Replacement of 2369803 with 2369801

Textar Apad aims to streamline the designation of 2369803 to 2369801.

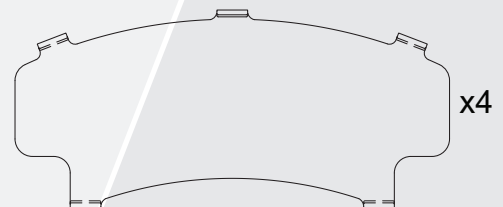
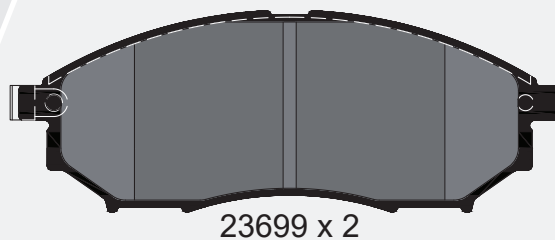
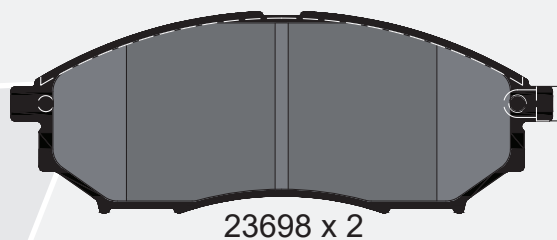
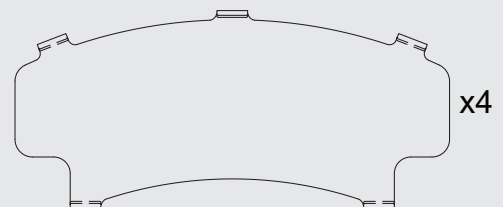
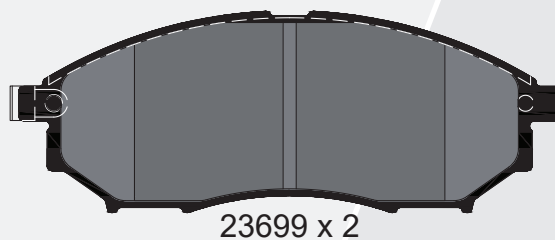
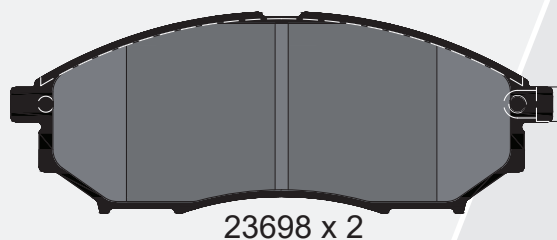
Given the identical outer dimensions of the brake pads, we can ensure seamless assembly and operation.

The difference between 2369801 and 2369803 is the 2369801 thickness is slightly thinner.

This consolidation extends coverage to a broader range of vehicles under a singular reference, namely 2369801 which is already covering applications of both part numbers.

157.3 x 58.3 x 17.6

157.3 x 58.3 x 16.6
